FOUNDATION INVESTIGATION REPORT

Doe Lake Road Interchange Bridge

WP 429-94-02, Site No. 42-142

Re: Final General Arrangement Drawing
Doe Lake Road Underpass
W.P. 429-94-02, Cont. 98-13, Site 42-142
Highway # 11, District 52, Huntsville

NSSP - Backfill to Integral Abutment-Augured Hole

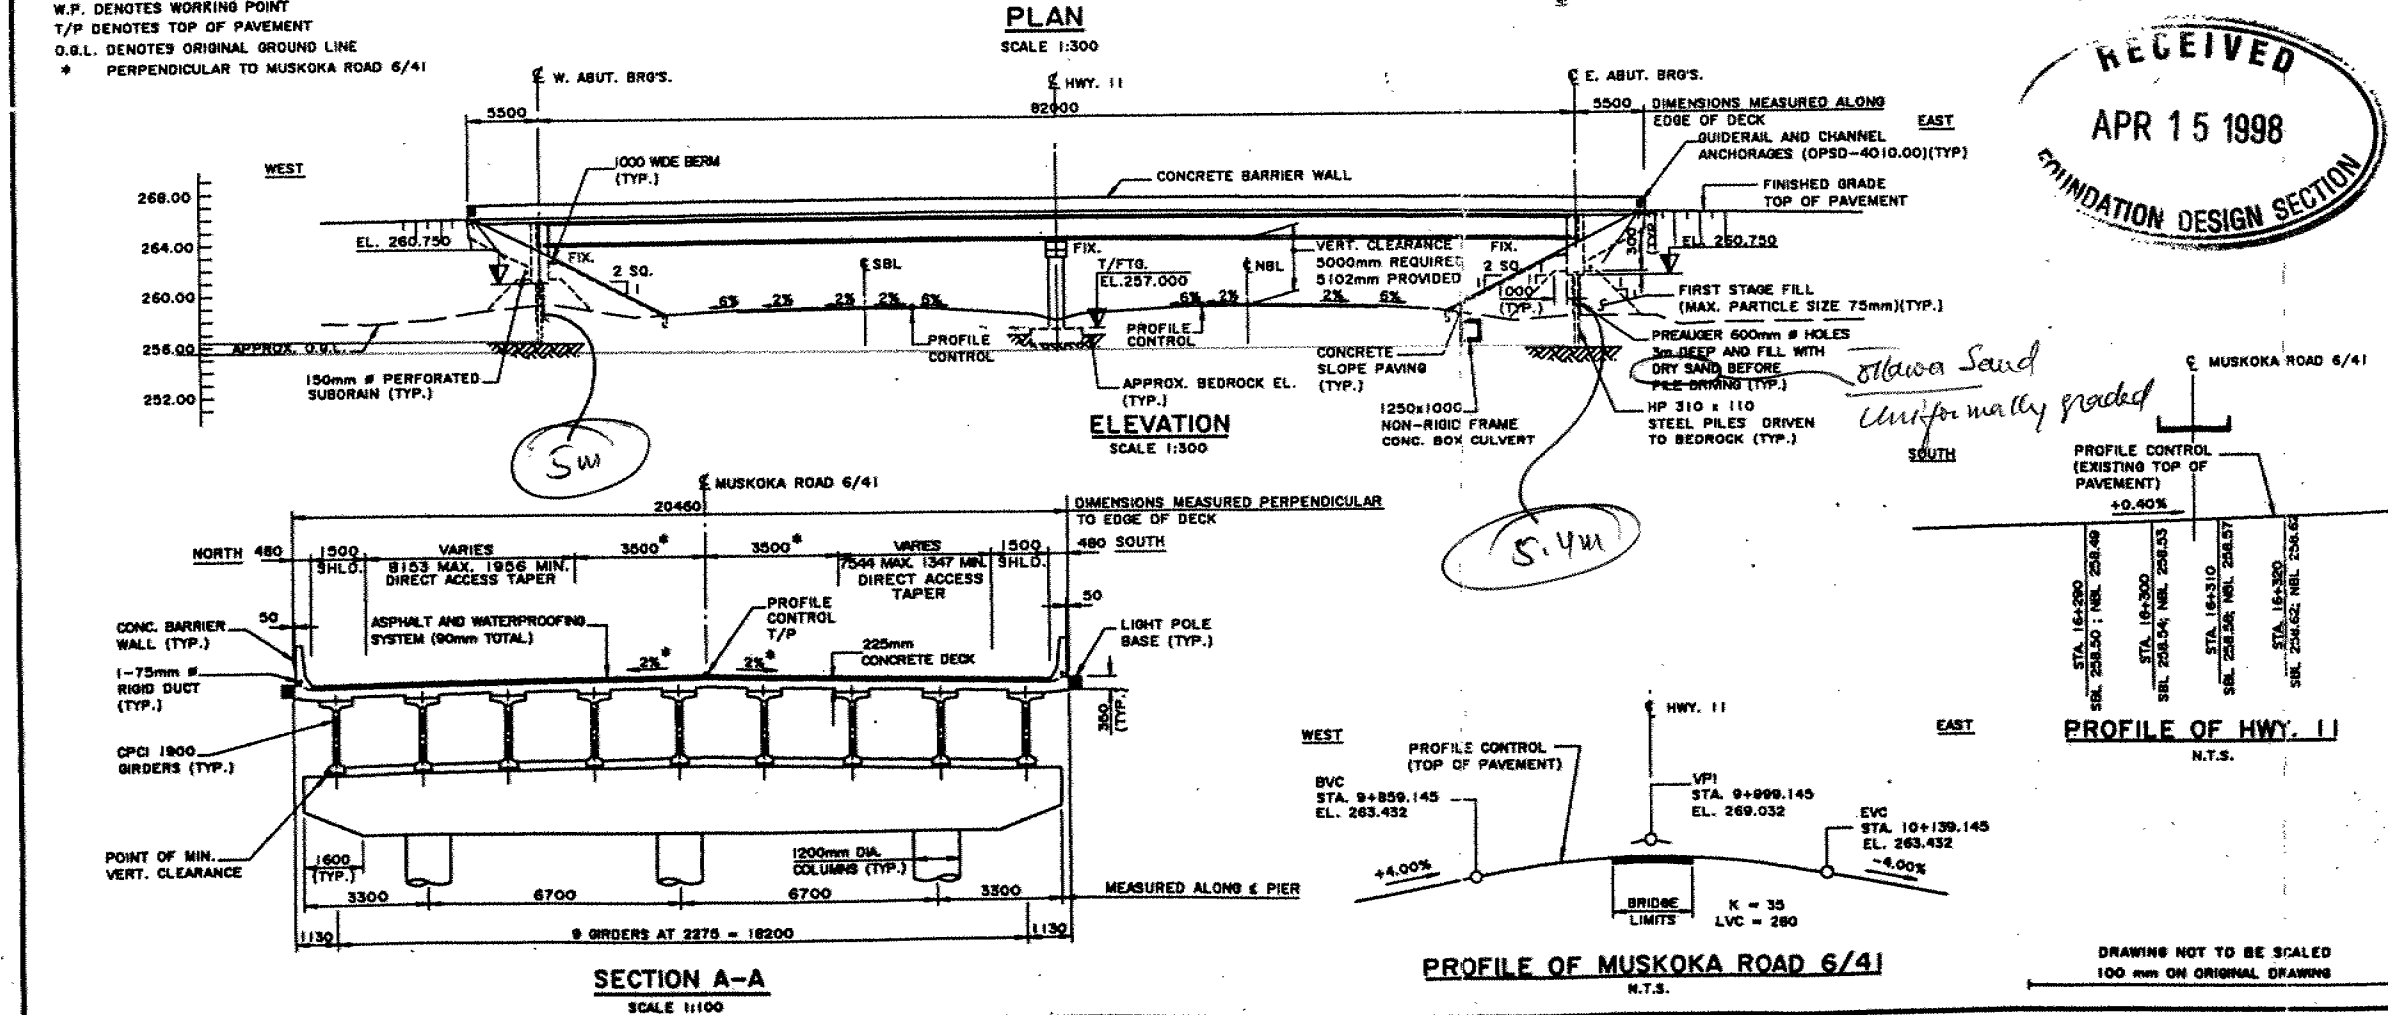
We reviewed the final GA drawing for the above project. Following are our comments:

- In our memo dated 1997 02 24 we had recommended that if integral abutments were selected for this structure, then pile socketing into the bedrock will be required. Since the pile length will range from 5m to 5.4m and the upper 3m of the piles will be within the preaugured holes and fill, the lower portion of the piles are not considered fixed. As a result the pile tips may become unstable. To prevent pile tips movement, the piles should be either socketed into the bedrock or rock point, such as Oslo point should be used.
- A note on the drawing suggests placing "dry sand" within the preaugured holes. The sand should be "Uniformly graded" Ottawa sand or equivalent. The gradation of the sand should meet the following criteria:
